NAVAL SURFACE WARFARE CENTER CARDEROCK DIVISION

Message:

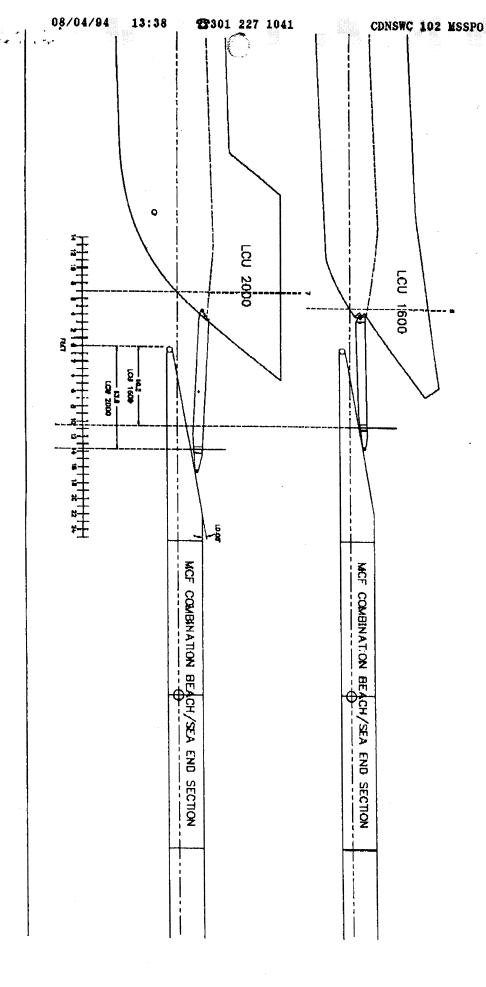
The attached diagram shows the optimum location for the Rhino Horn. The estimated optimum location is approximately 4 feet more inboard than what LSI is building to. Note on the diagram that LSI' horn location, 8 ft from tip of module, is very near the waterline. During the transition of cargo, the fwd end of both the lighter and the sea section will submerge and thereby increase the draft waterline. At this point, the Rhino horn (at LSI's location) may even be partly under water. Locating the Rhino horn up higher is better in terms of trim during cargo transfer. However, the lighter would have to get closer to the fwd end of beach/sea ramp - see next paragraph.

Note the proximity of the lighter bow hull to the sea end section. A fender should be installed on the tip of sea end section to prevent any possible damage. I will volunteer to design a fendering system for this application. Please call me to discuss.

It may be smart for us to consider requesting LSI to change the location of the Rhino Horn before its too late.

APPROXIMATE RHINO HORN LOCATION ESTIMATED SEPARATELY FOR EACH VESSEL

APPROXIMATE COMPROMISED RHINO HORN LOCATION
